Attachment A to AEP:NRC:0745F
Revisions to Proposed Technical Specifications
(As Found in Attachment A to AEP:NRC:0745C)

Attachment E to AEP:NRC:0745F
Responses to Reactor Physics Questions
in Letter, Varga to Dolan, June 29, 1983

Attachment F to AEP:NRC:0745F
Responses to Fuels Questions
in Letter, Varga to Dolan, June 29, 1983

FIGURE 10
RCCA WITHDRAWAL AT POWER 100% POWER

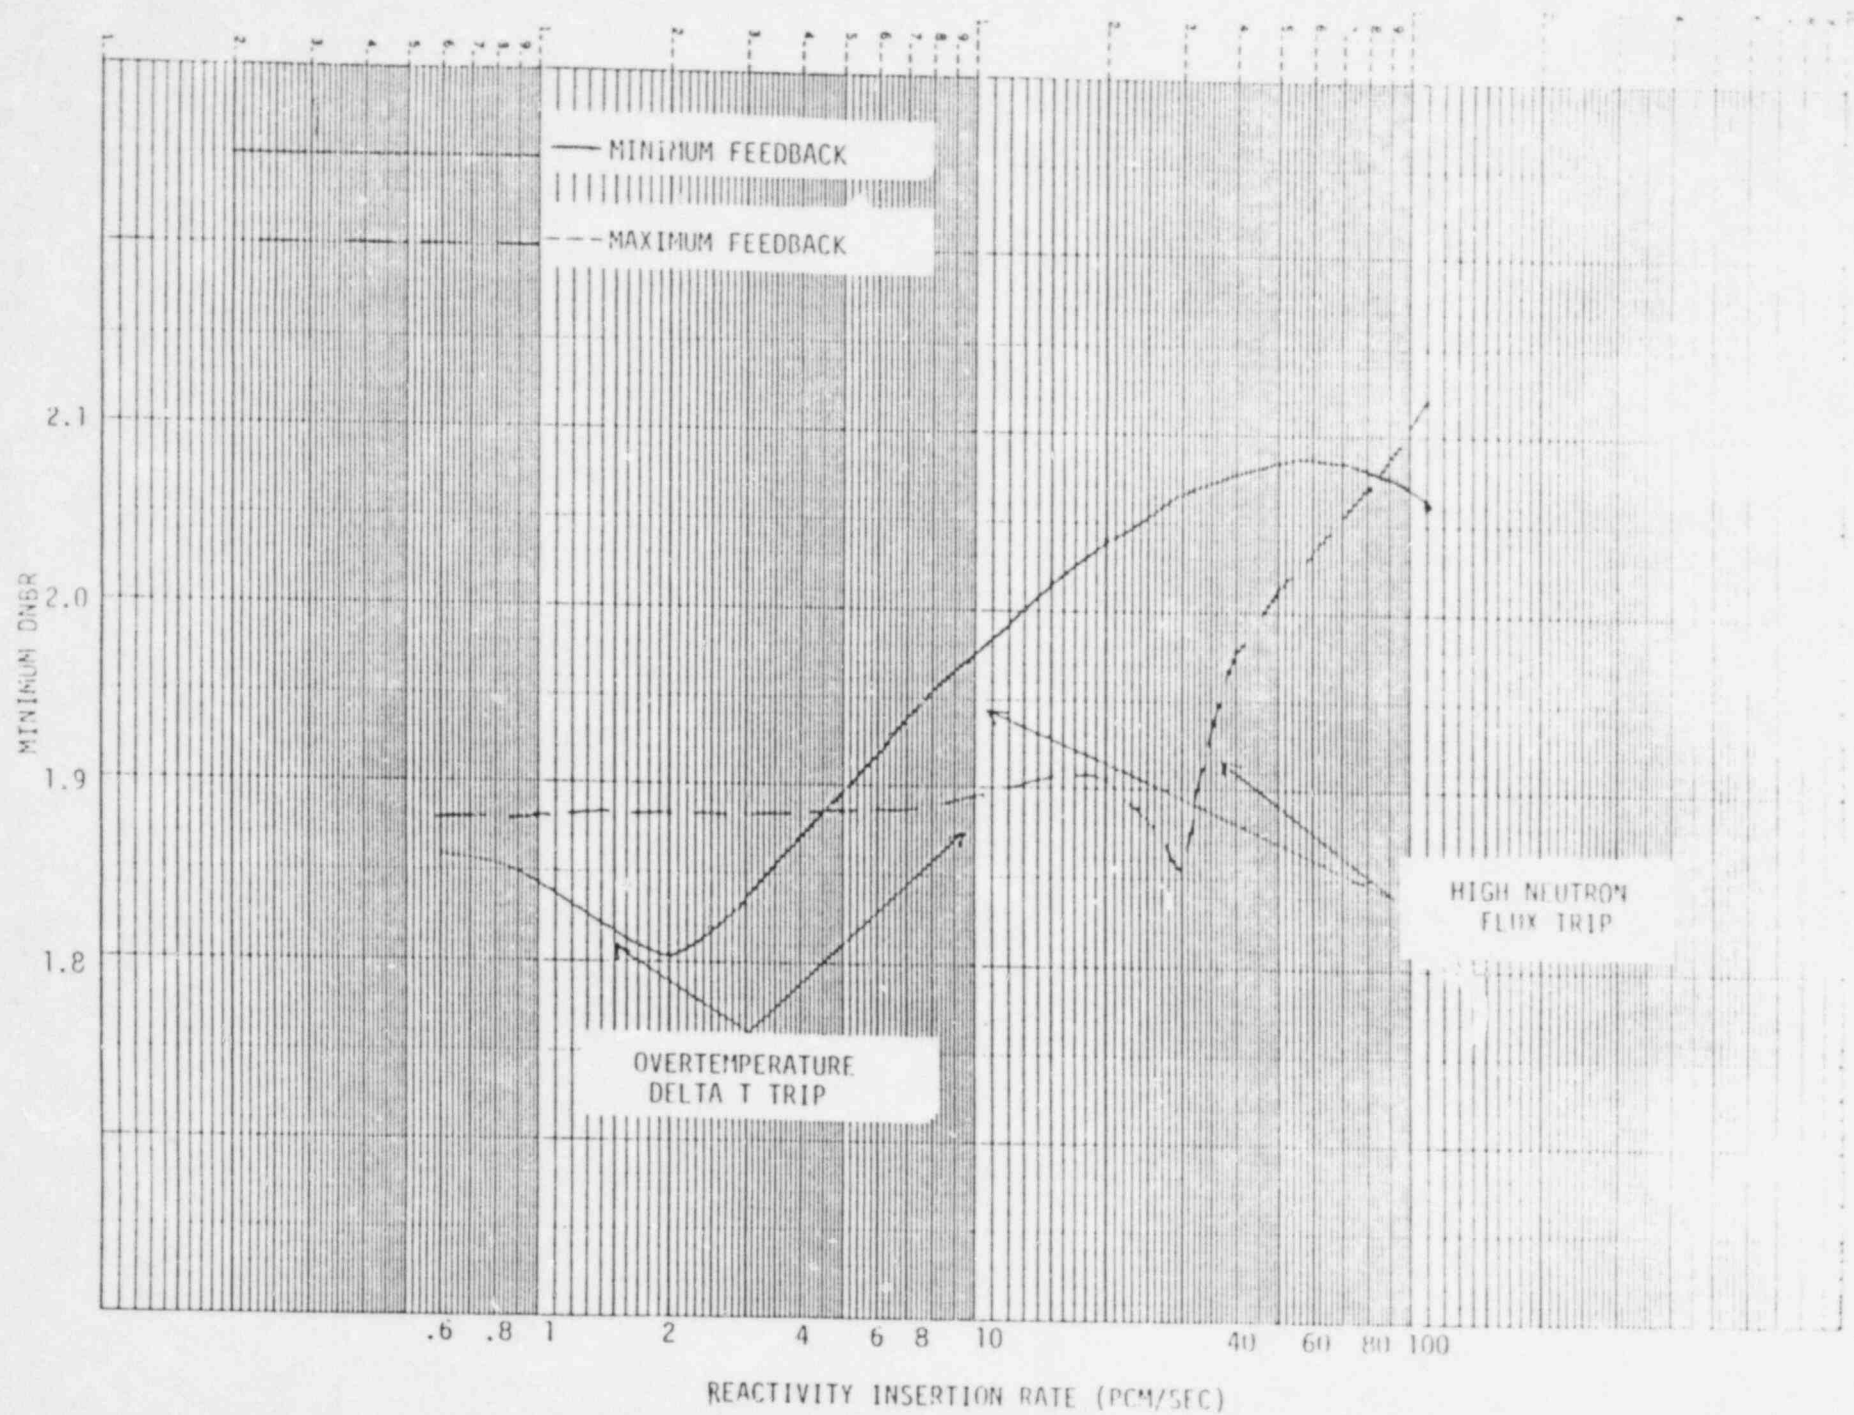
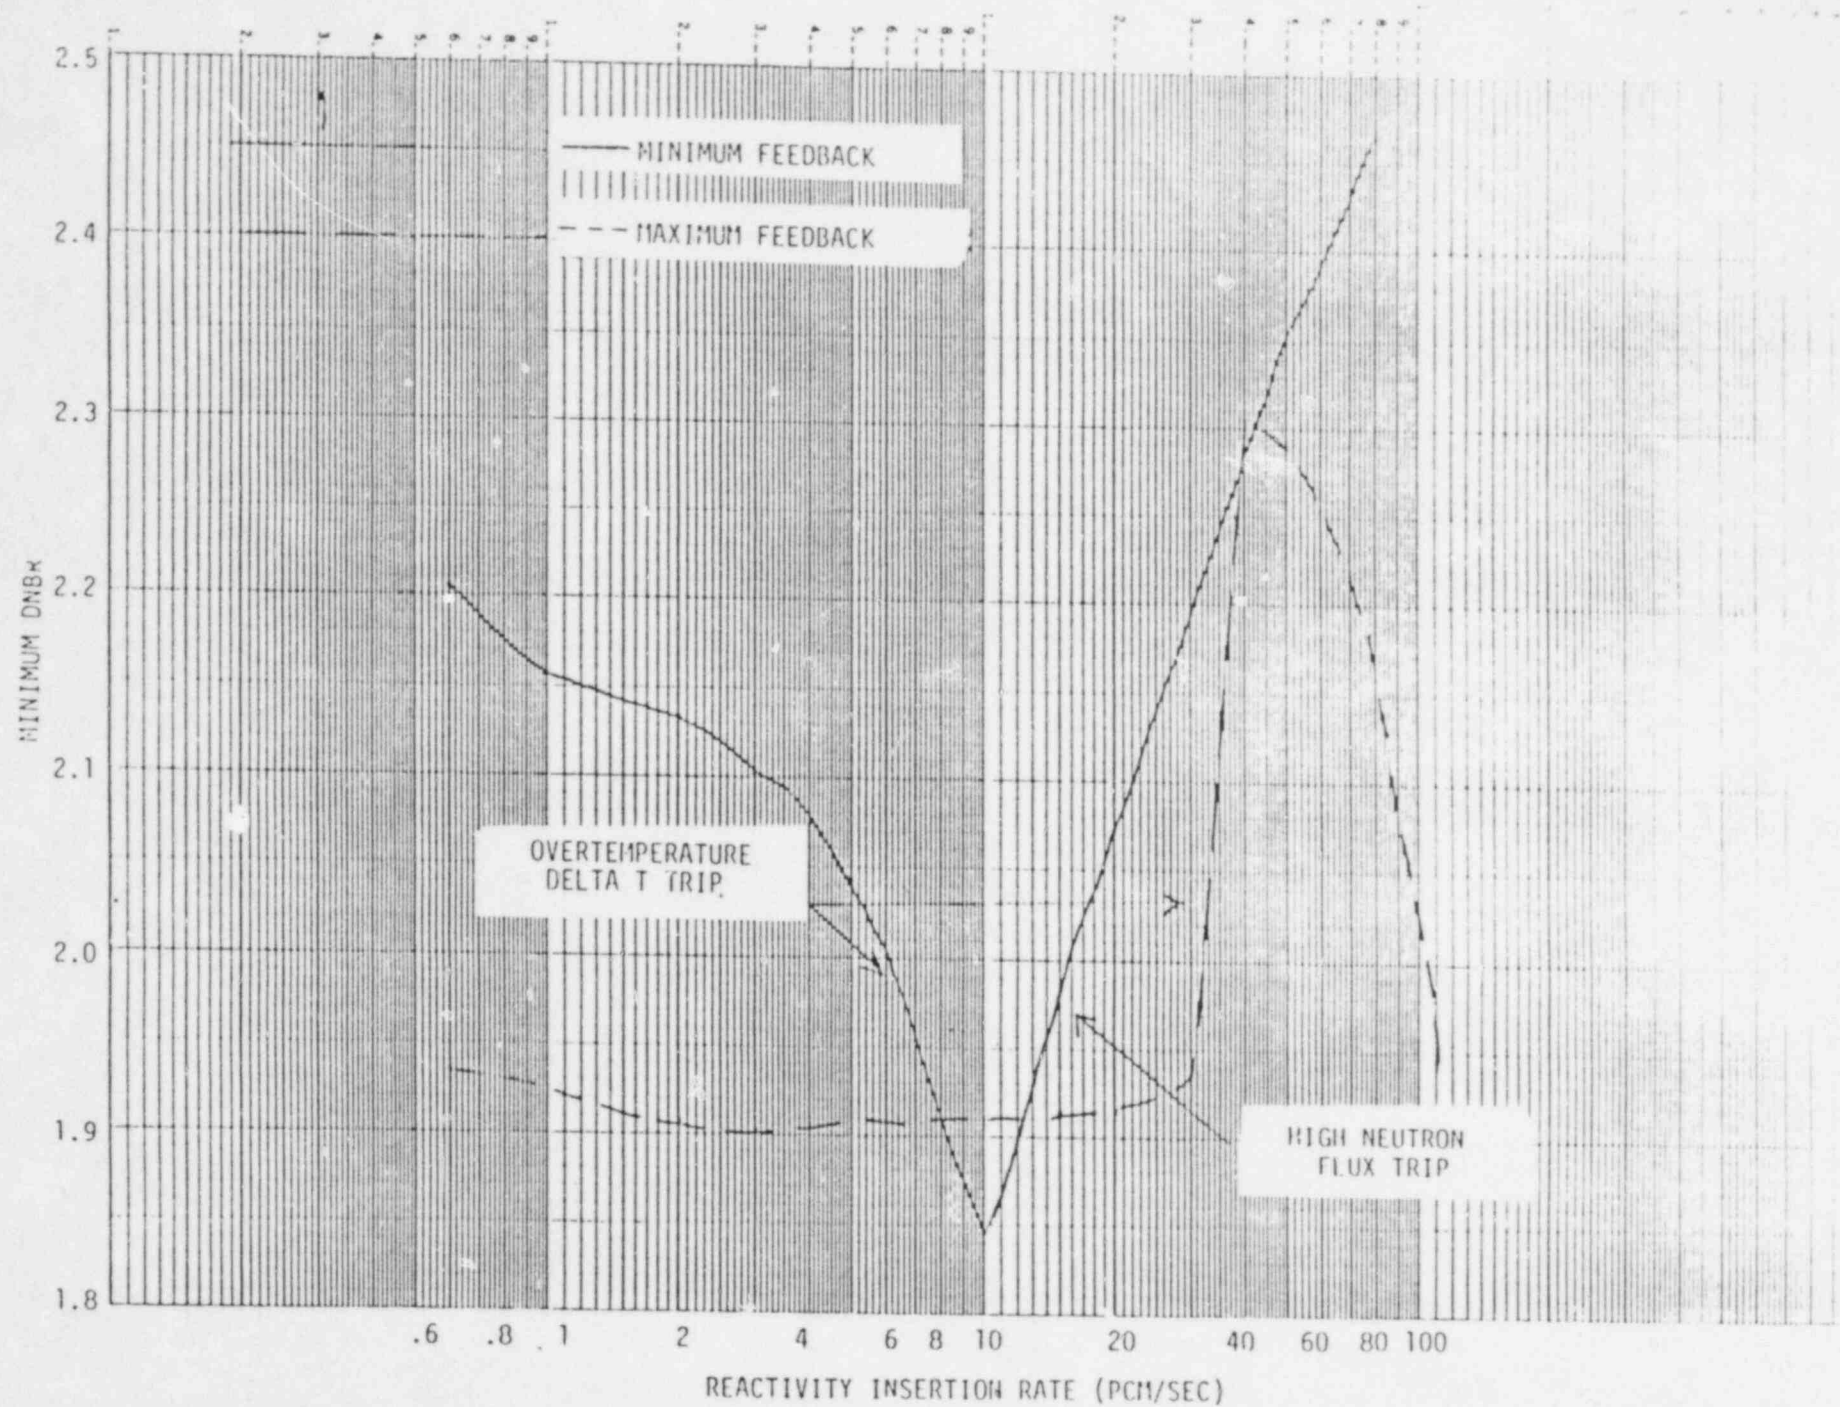
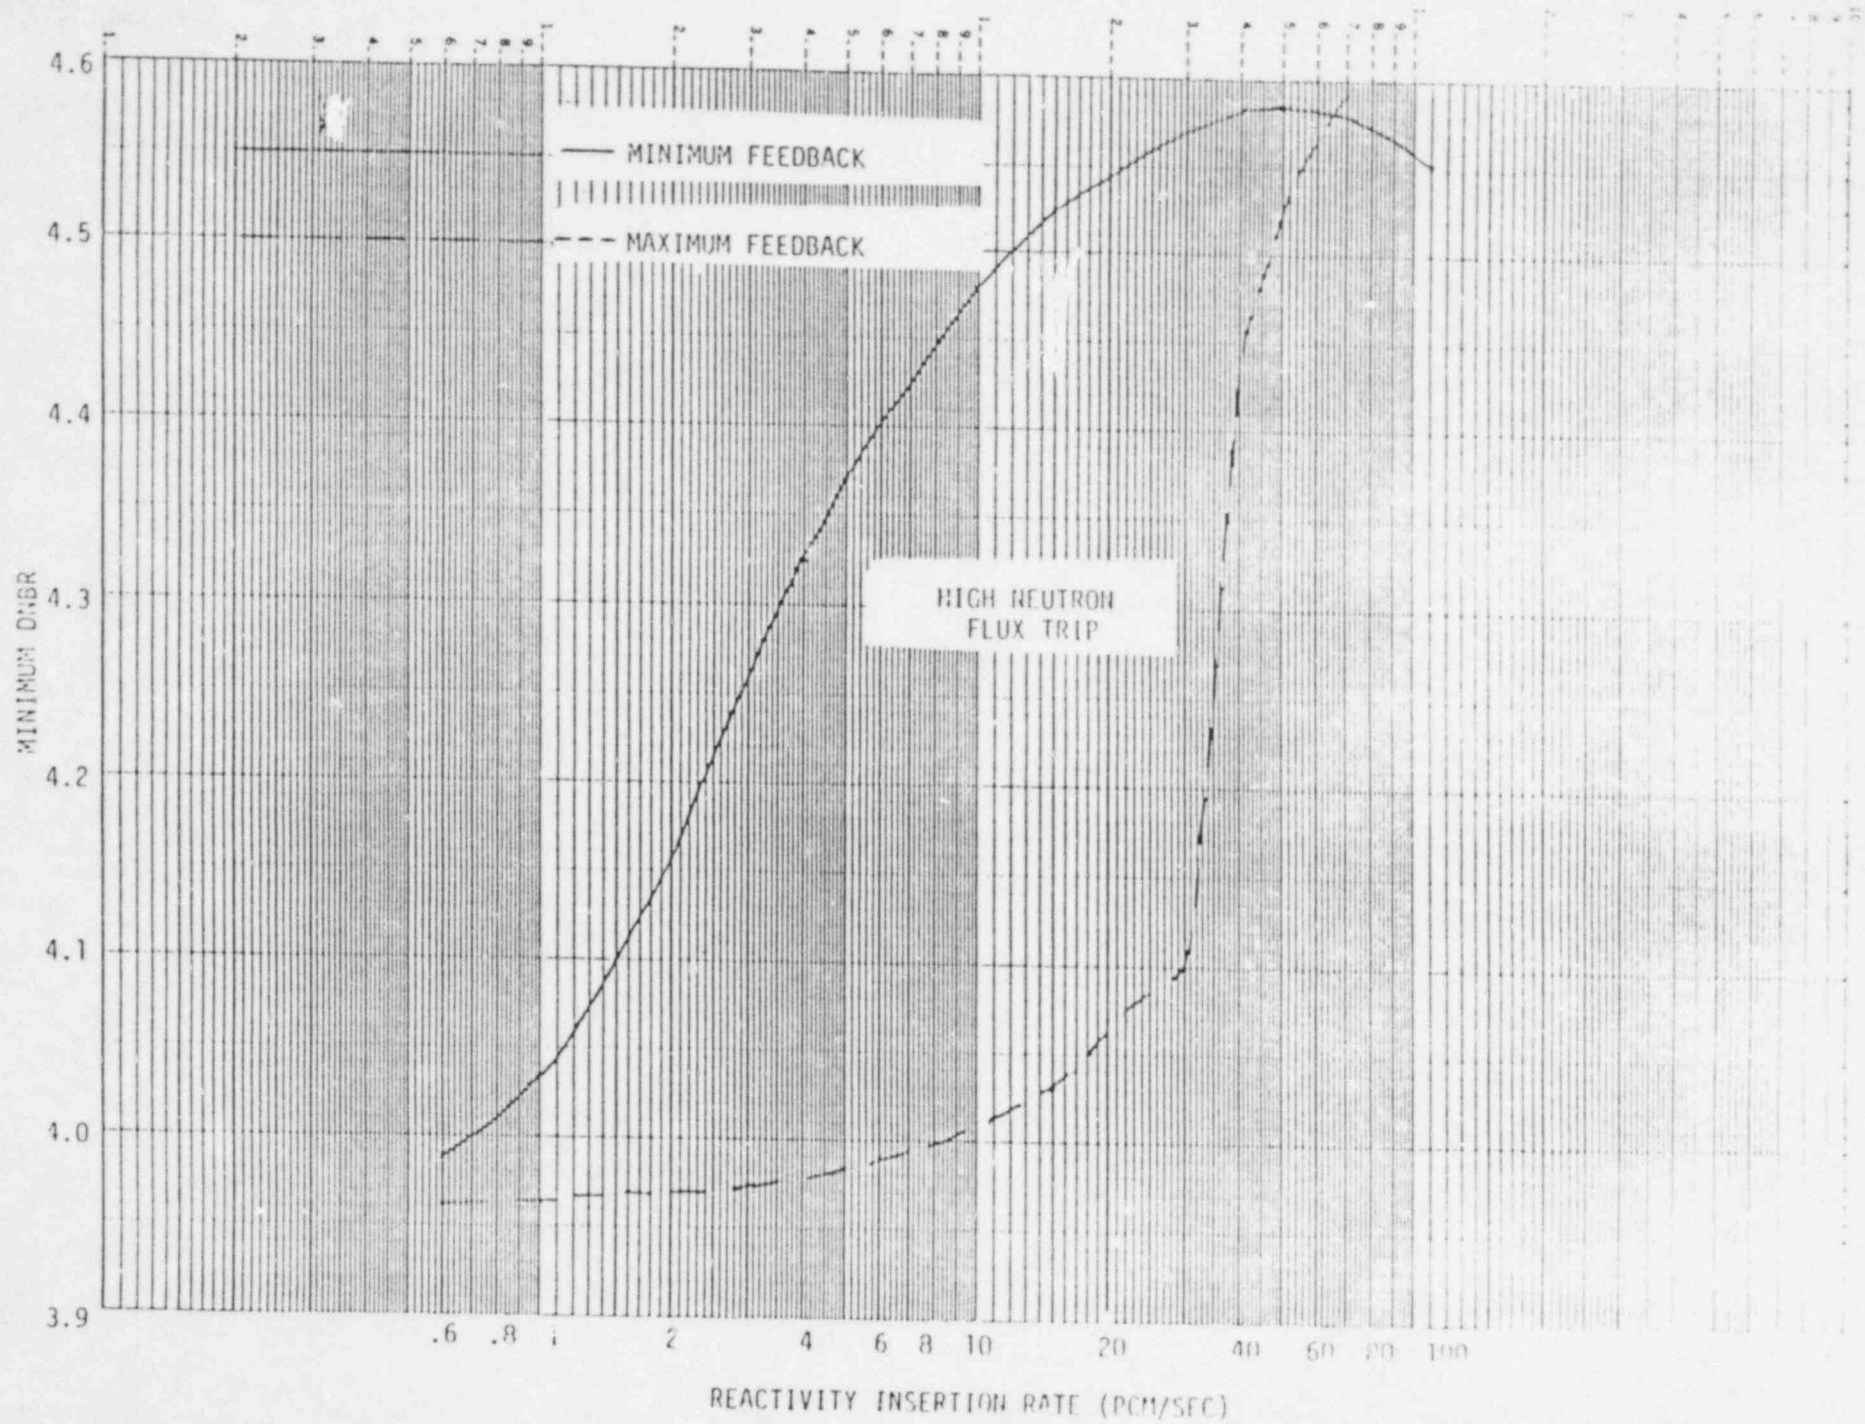
Q4. In Figures 10, 11, and 12 of Attachment C, the distinction between maximum and minimum feedback curves is not clear. Please clarify.

Response: The minimum feedback curves are the solid ones and the maximum feedback curves are the dashed ones for all three figures. Please see the revised like - numbered figures which clearly identifies this.
